RENESAS TECHNICAL UPDATE

Product Category	MPU/MCU		Document No.	TN-SH7-A826A/E	Rev.	1.00
Title	SH7450 Group, SH7451 Group User's Manual Hardware Errata Rev.A		Information Category	Technical Notification		
Applicable Product	SH7450 Group, SH7451 Group	Lot No.	Reference Document	SH7450 Group, SH7451 Group User's Manual: Hardware Rev.1.10 (R01UH0286EJ0110)

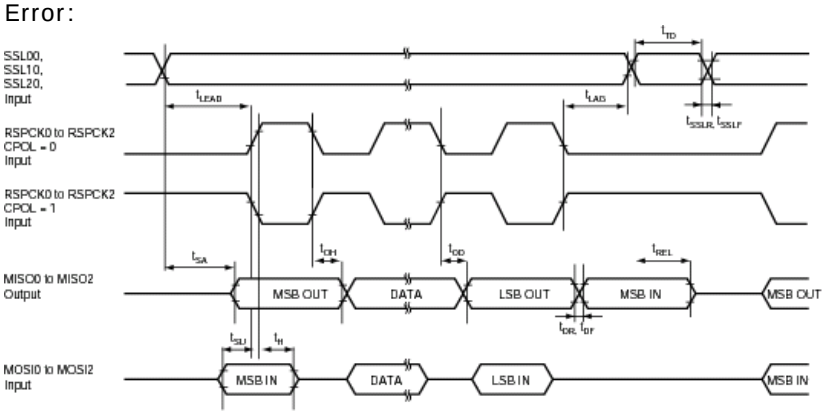
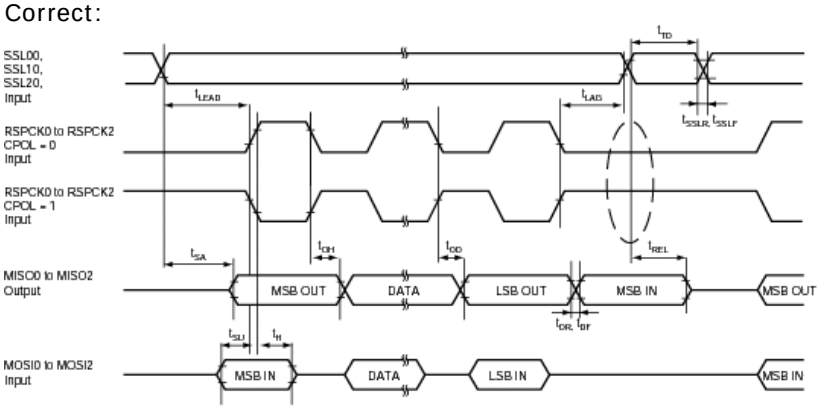
<table>
<tr><th>Rev.</th><th>Page</th><th>Part</th><th>Contents</th></tr>
<tr><td>Adds by REV.A</td><td>38-33</td><td>Table 38.26 RSPI Timing</td><td>
Table 38.26 RSPI Timing : Incorrect description corrected.
Error:
<table>
<tr><th colspan="2">Item</th><th>Symbol</th><th>Min.</th><th>Max.</th><th>Unit</th><th>Figures</th></tr>
<tr><td>Data input setup time</td><td>Slave</td><td>t_{SU}</td><td>25 + 2 x t_{cyc}</td><td>-</td><td>ns</td><td>38.28 to 38.31</td></tr>
</table>
Correct:
<table>
<tr><th colspan="2">Item</th><th>Symbol</th><th>Min.</th><th>Max.</th><th>Unit</th><th>Figures</th></tr>
<tr><td>Data input setup time</td><td>Slave</td><td>t_{SU}</td><td>25 - 2 x t_{cyc}</td><td>-</td><td>ns</td><td>38.28 to 38.31</td></tr>
</table>
</td></tr>
<tr><td>Adds by REV.A</td><td>38-35</td><td>Figure 38.30 RSPI Timing (Slave, CPHA = "0")</td><td>
Figure 38.30 RSPI Timing (Slave, CPHA = "0") : Incorrect description corrected. O in a figure shows the added part.

Error:

Correct:
